RHB 041 -80

MFN 104-80

SUBJECT: NRC REQUEST FOR ADDITIONAL INFORMATION, DFFR ROUND 2
QUESTIONS

NRC QUESTIONS DATED JANUARY 14, 1977, WITH RESPONSES

Figure 1. Effect of Variations in the Initial Pool Velocity on the Maximum Pool Swell Velocity

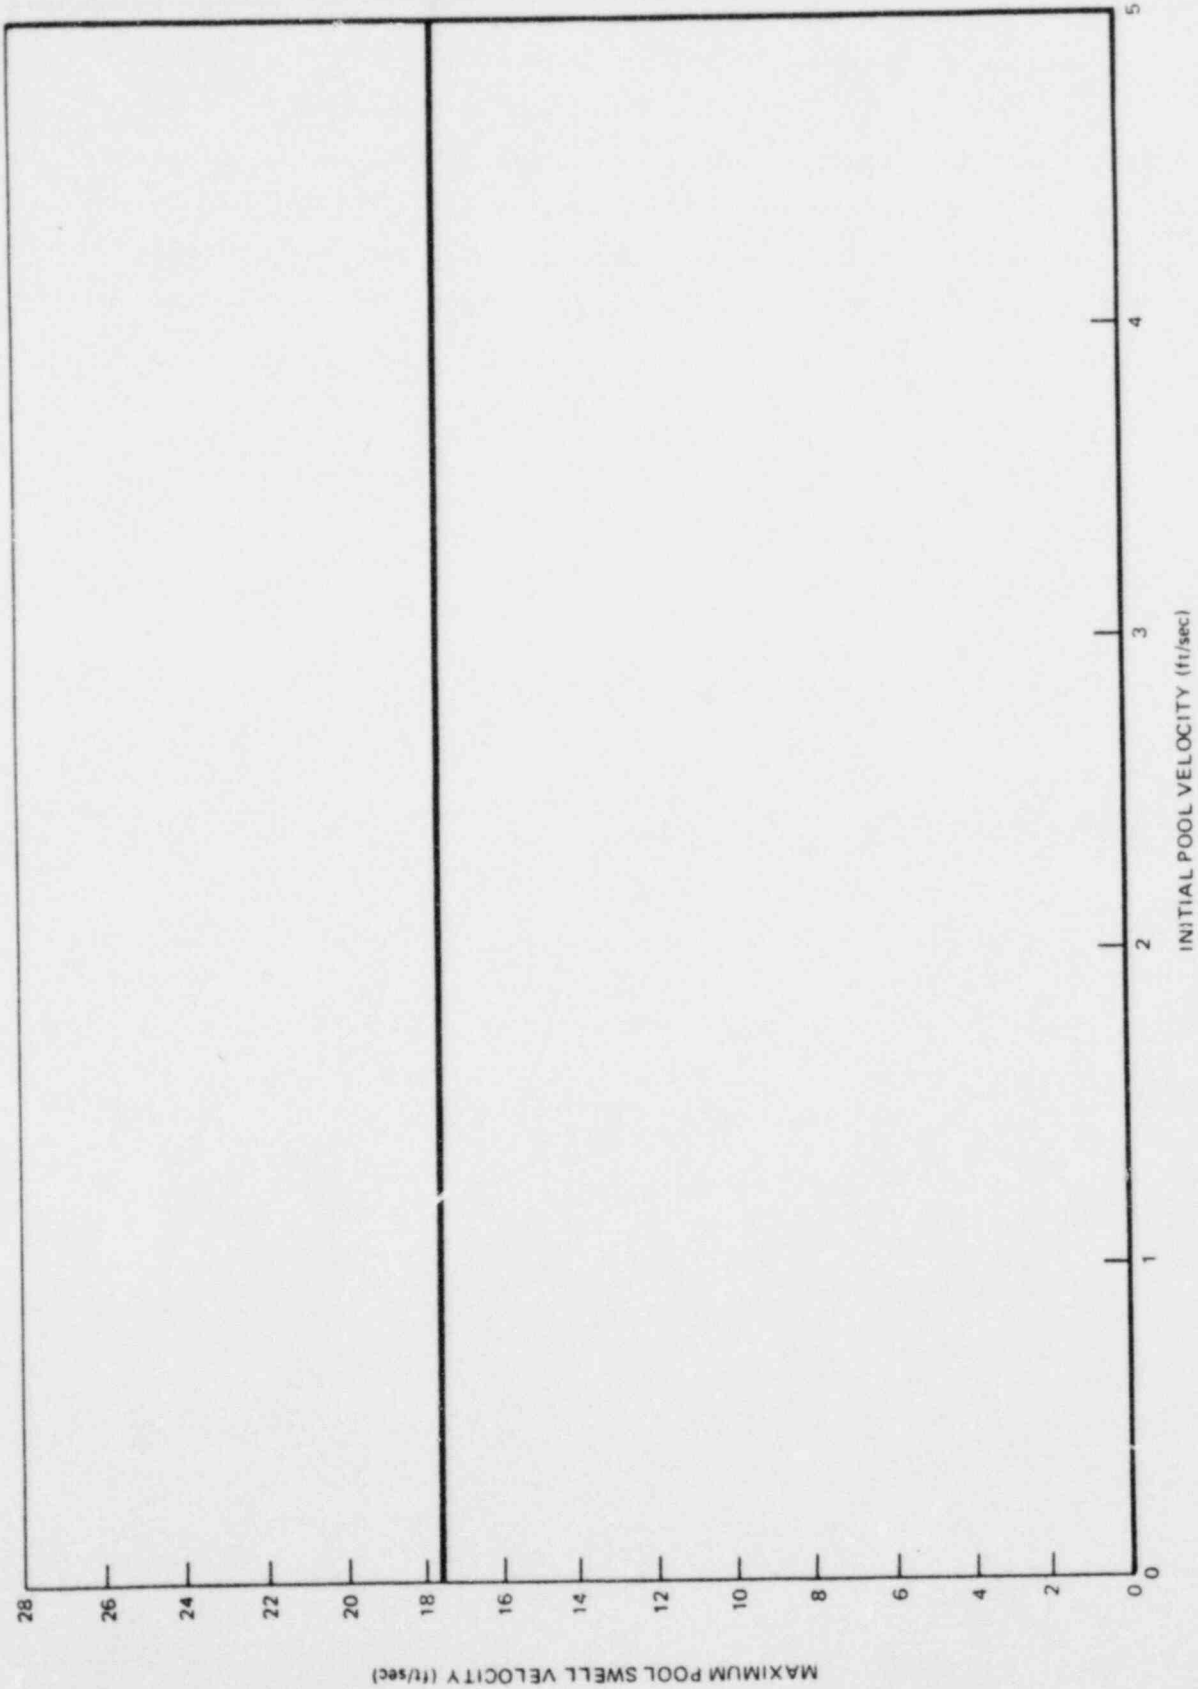
QUESTION M020.35 (Continued)

A value of 2.5 ft/sec is generally used in the model. For this sensitivity study, the initial velocity was varied from 0 to 5 ft/sec. As can be seen in Figure 1, this variation in the initial velocity has an insignificant effect on the maximum pool surface velocity.

Figure 1. Drywell Pressure Short Term Response Recirculation
Line Break - La Salle

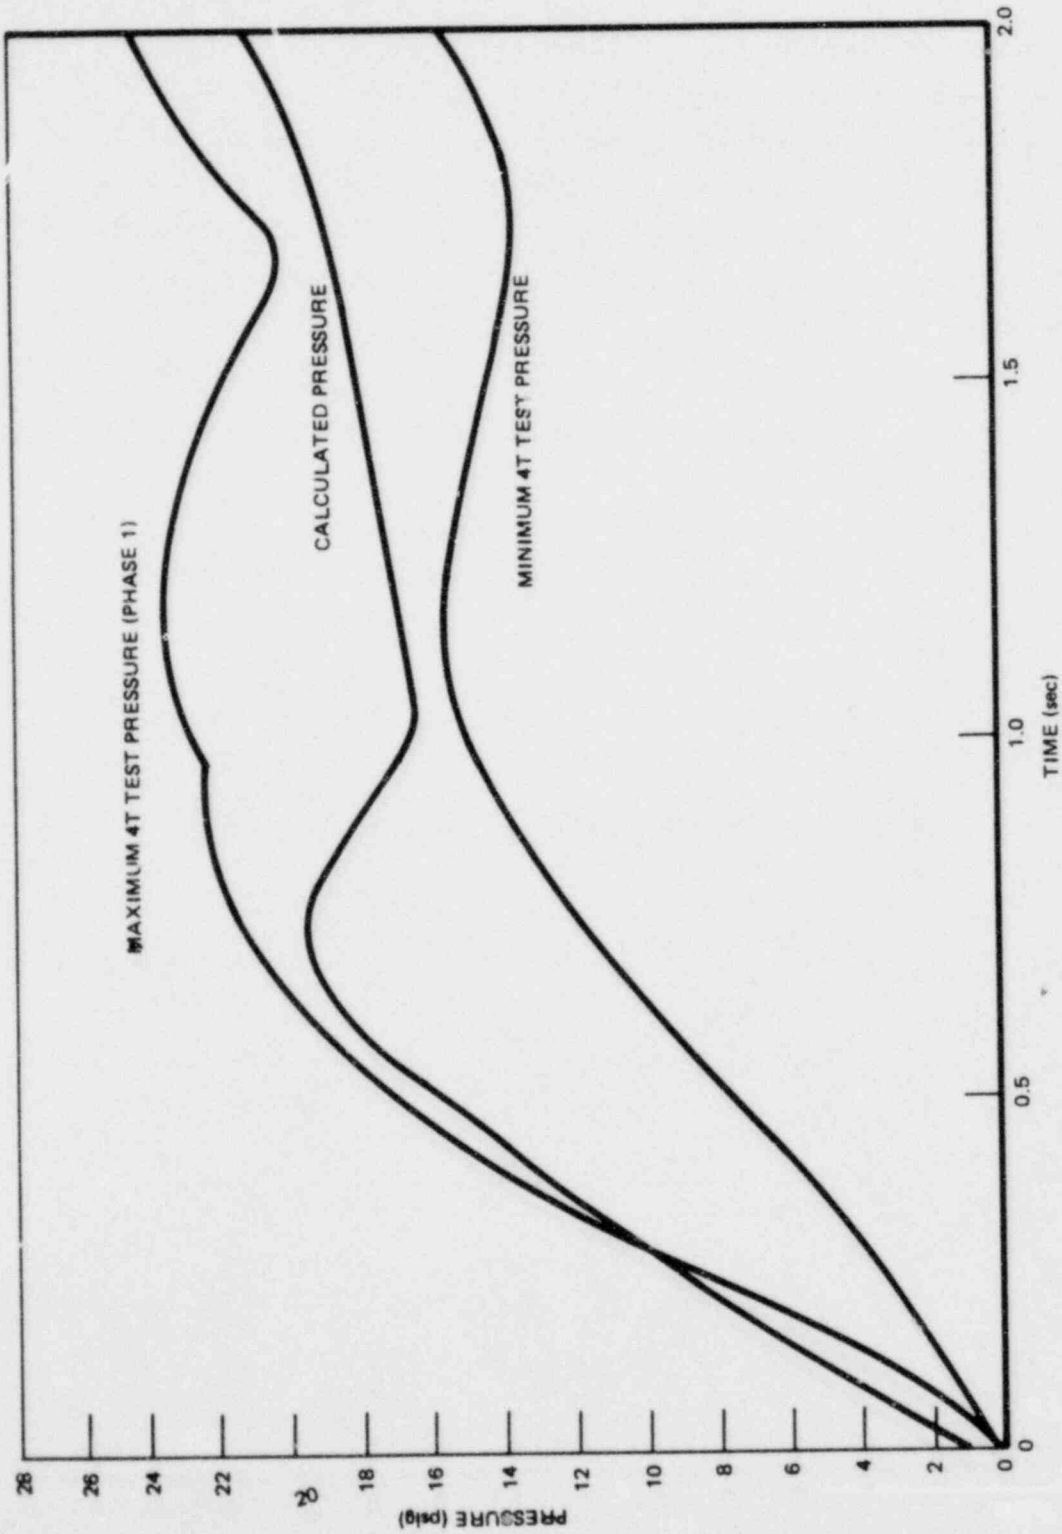
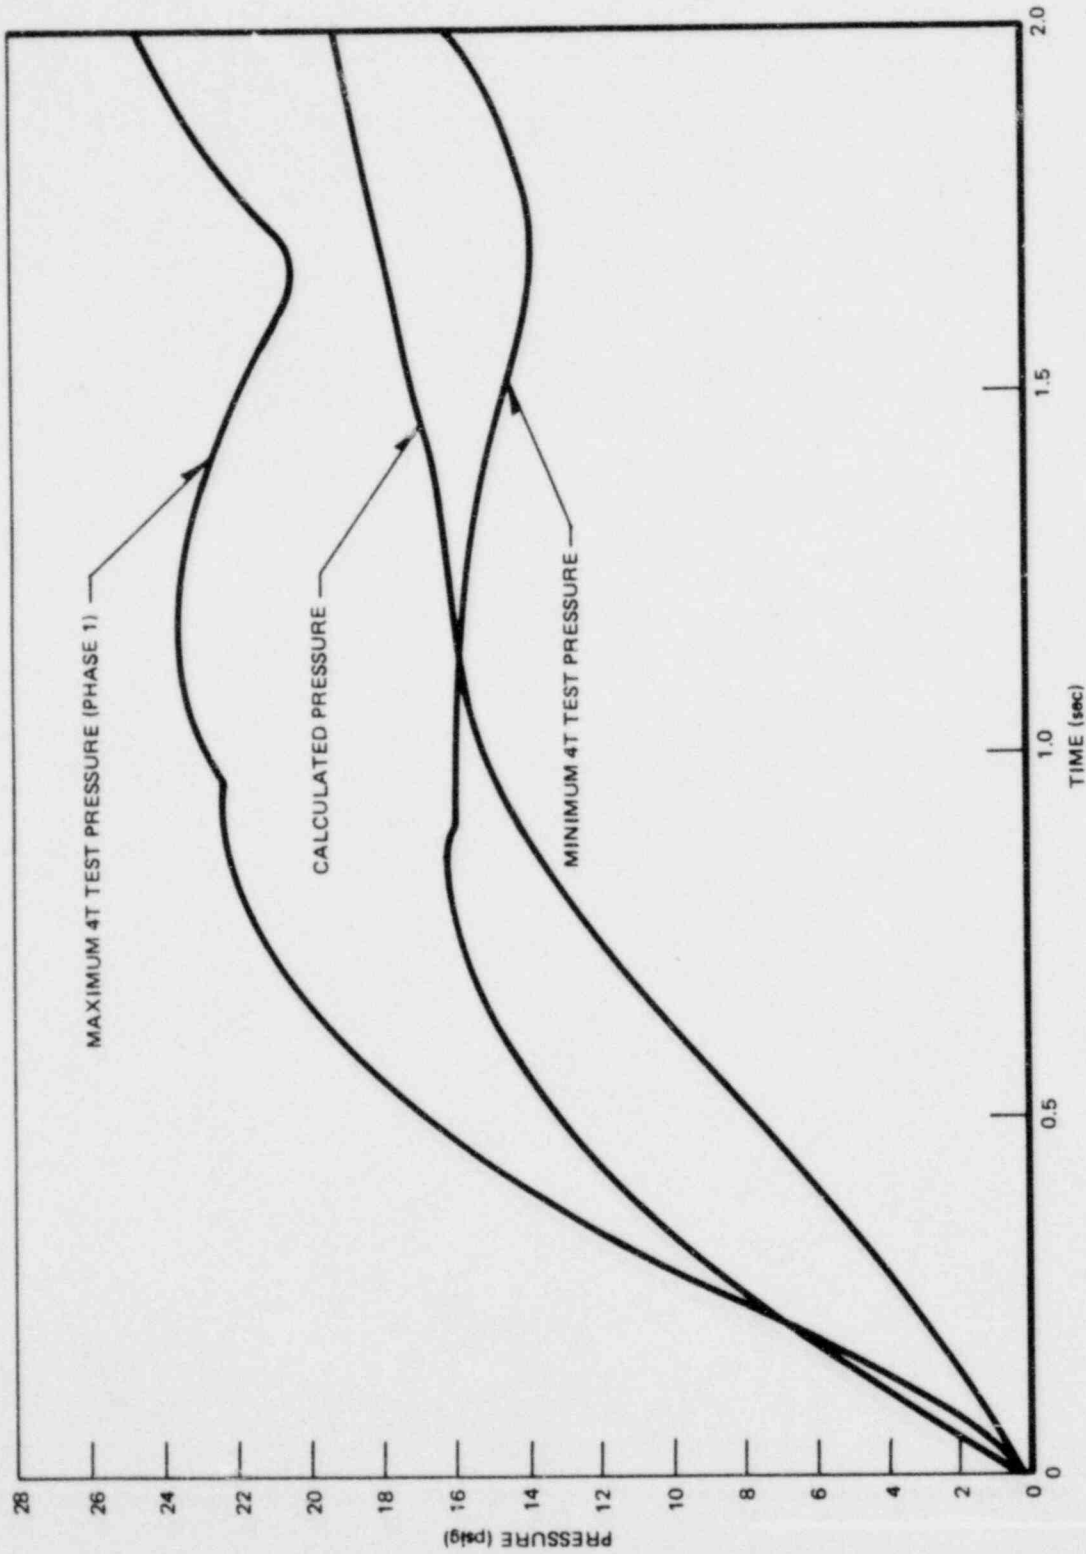
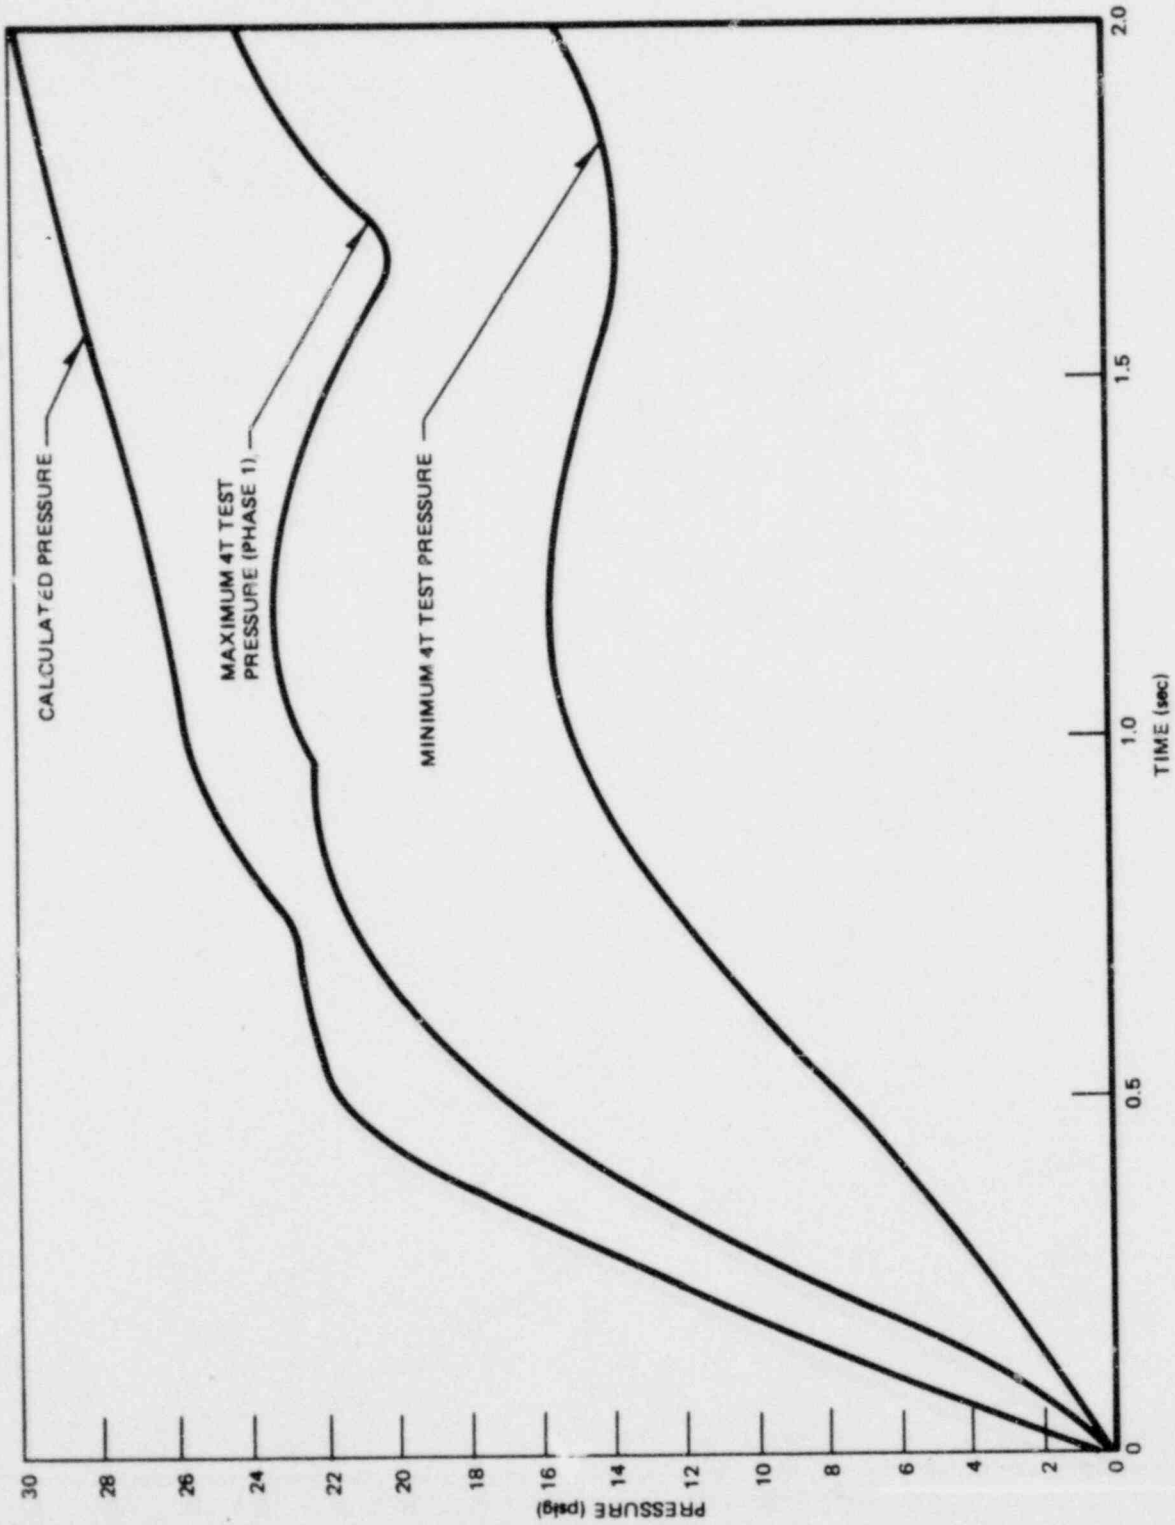
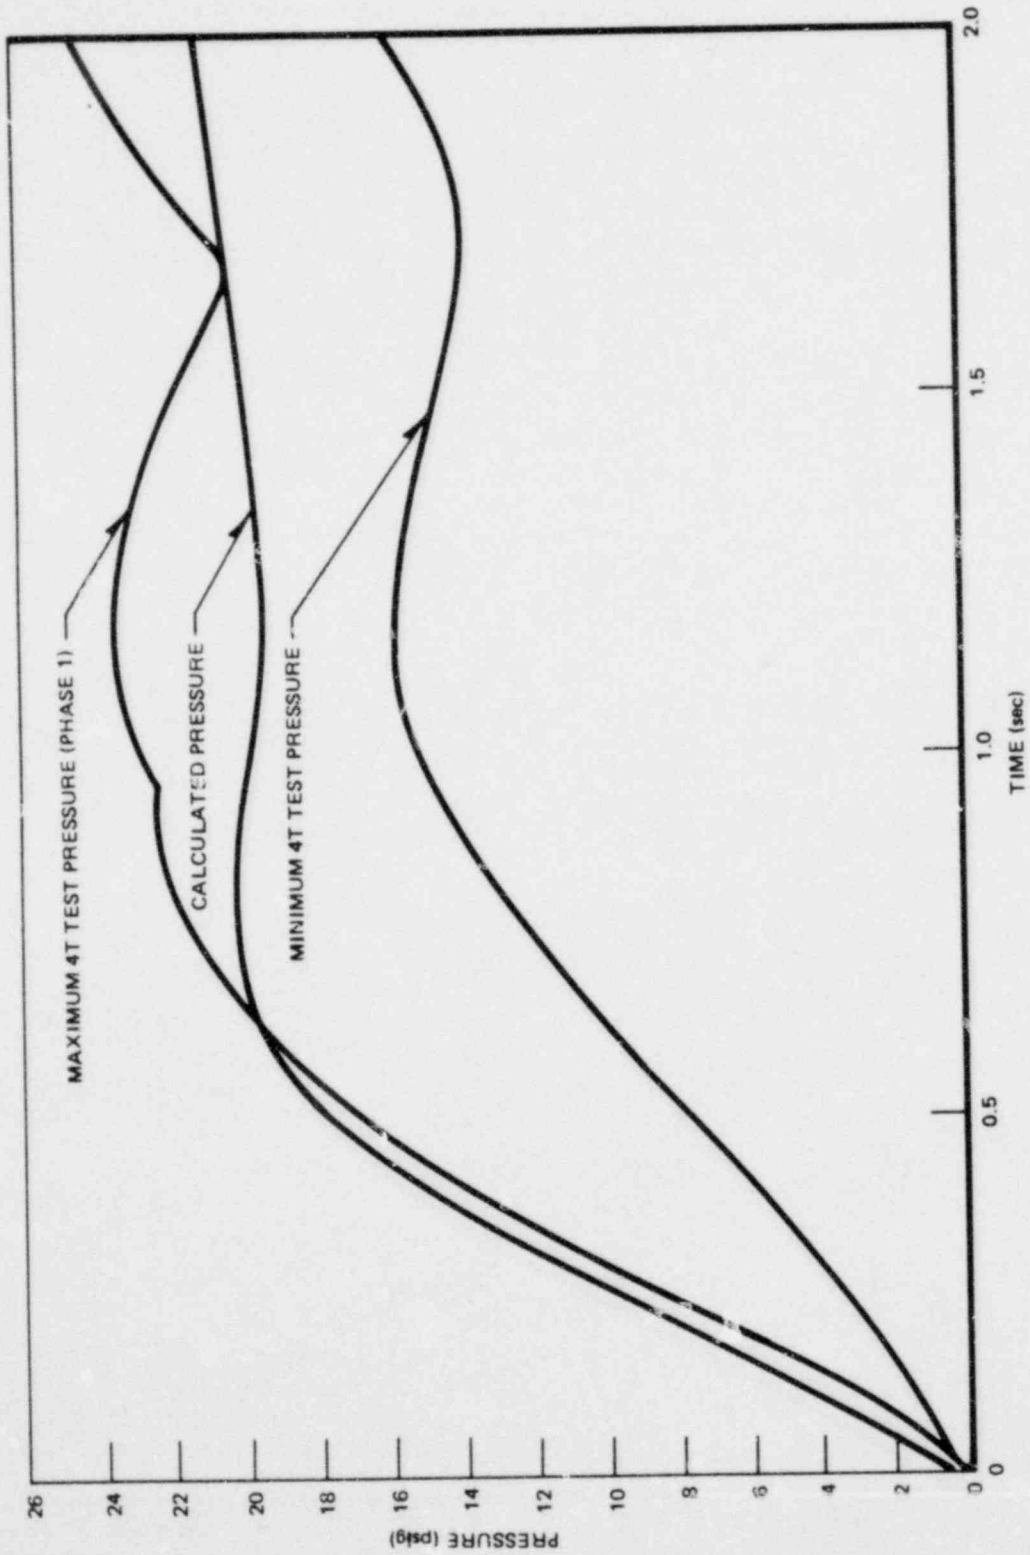
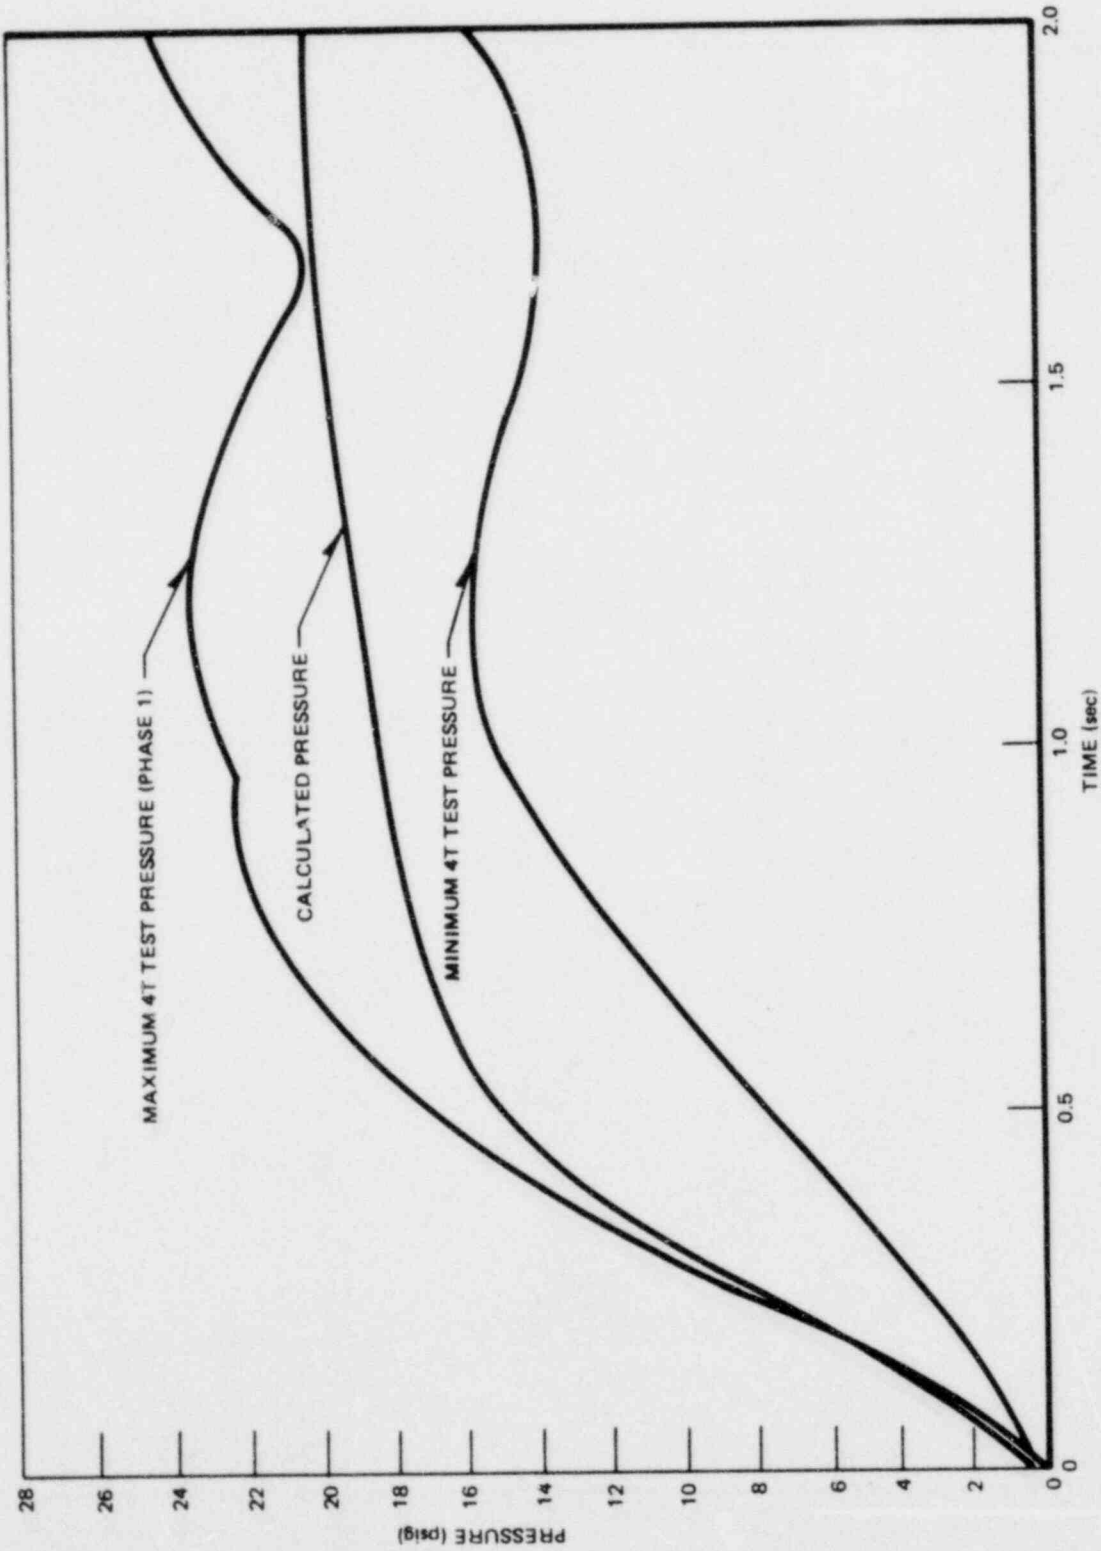
4. The calculated drywell pressure response and the enthalpy flux in the downcomer vent should be compared to the 4T 2-1/2 in. and 3 in venturi data.

The following figures 1 through 9 show comparisons between the drywell pressure transients calculated for each Mark II containment project and the bounding pressure traces from the applicable Phase 1 4T tests (NEDE-13442-P) (24-in. downcomer vents, closed tank, preheated drywell) over the period of interest for pool swell ($t < 2$ sec).
